TECHNICAL NOTE 4 (TN04)

**Stage 1 Road Safety Audit
Designers Response**

**Albrighton South
(Application 24/02108/OUT)**

December 2024

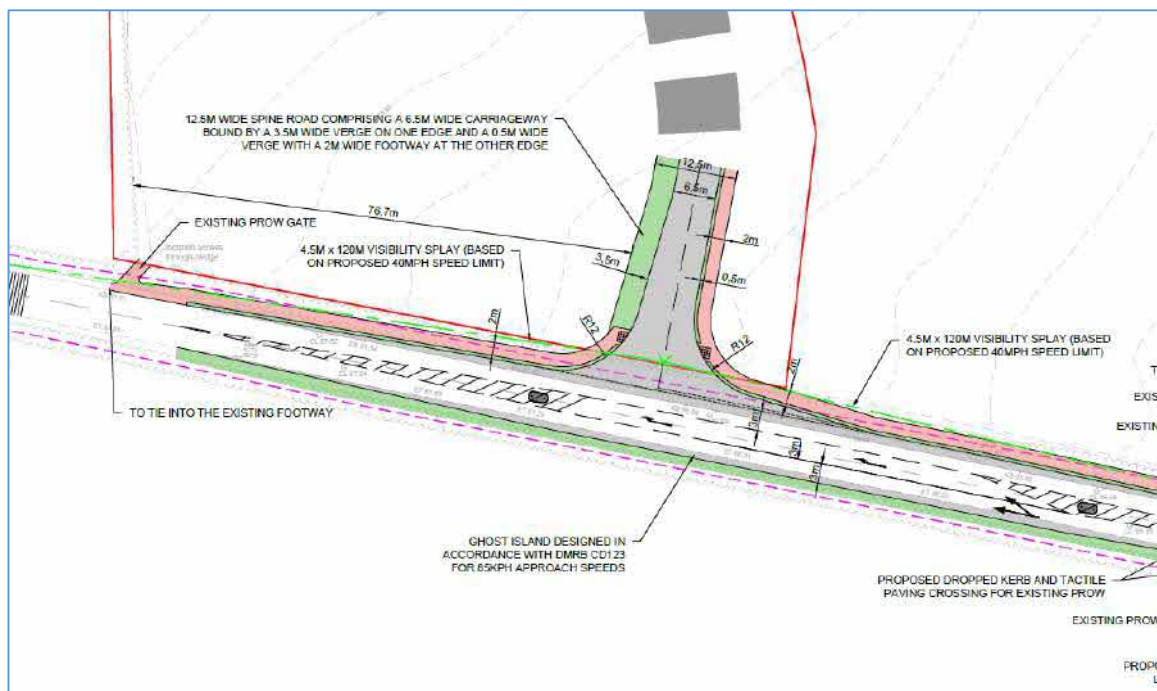
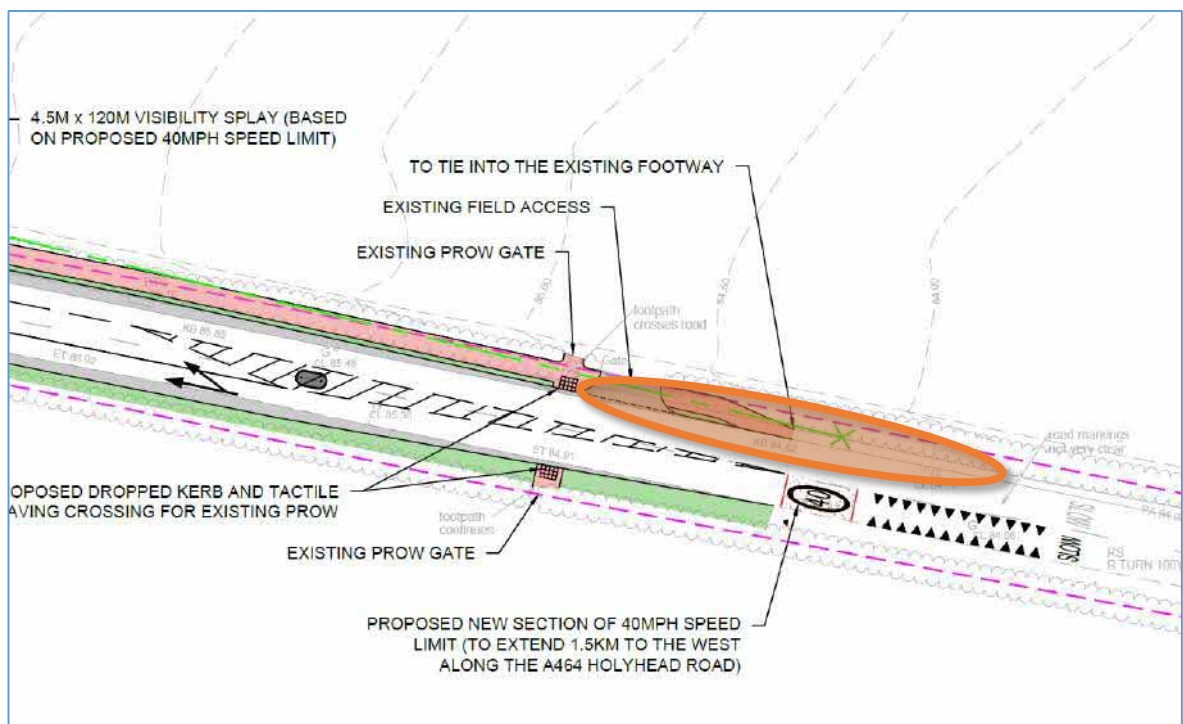
Summary: Lack of visibility risks junction pull-out type collisions.

The drawing provided show visibility splays based on the proposed 40mph speed limit. As mentioned above Holyhead Road is currently subject to the national speed limit and whilst it is appreciated that the proposals include gateway features and rumble strips / 40mph roundels along Holyhead Road, some high vehicle speeds were observed during the site visit and it is unclear whether, especially given the proximity of the junction to the start of the 40mph speed limit, the proposed measures will have the desired reduction in speeds. Should insufficient visibility be provided there is a risk of drivers exiting the junction into the path of vehicles on Holyhead Road resulting in side-impact or shunt type collisions.

It is recommended that unobstructed visibility splays commensurate with likely vehicle speeds, as opposed to the speed limit, are provided at the junction.

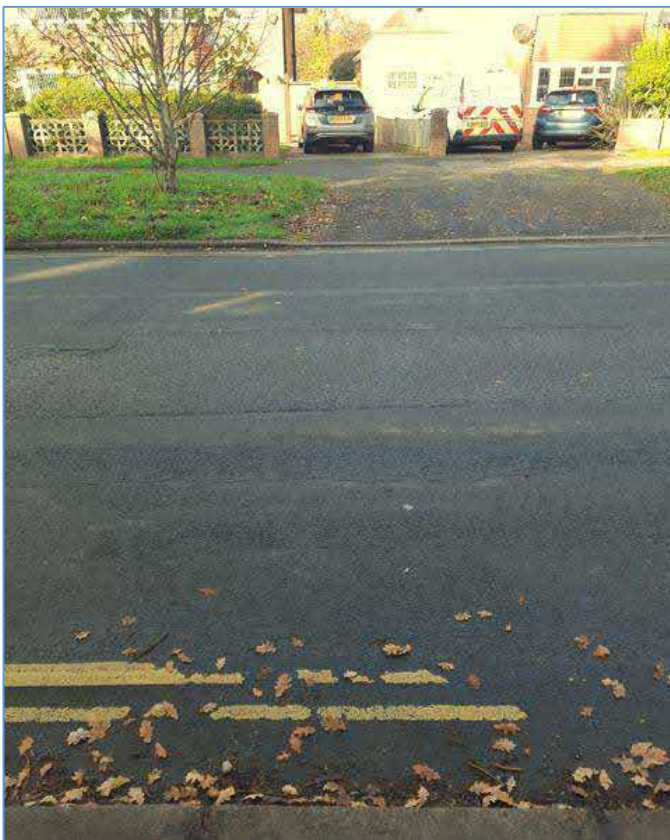
The eastern side of the proposed pedestrian crossing here is located within the access for the Albrighton Caravan Storage and the adjacent plot / field access. The crossing point is therefore likely to be overrun, potentially by large or towing vehicles, resulting in damage to the proposed tactile paving and creation of a trip hazard. Furthermore, whilst the current boundary treatment to the north allows for reasonable visibility of approaching vehicles, there is potential for an alternative boundary treatment that will obscure visibility of and for pedestrians starting to cross here, risking vehicle to pedestrian collisions.

It is recommended that the crossing is relocated outside of the adjacent access and to a location either where good visibility of approaching traffic is available or away from the junction.
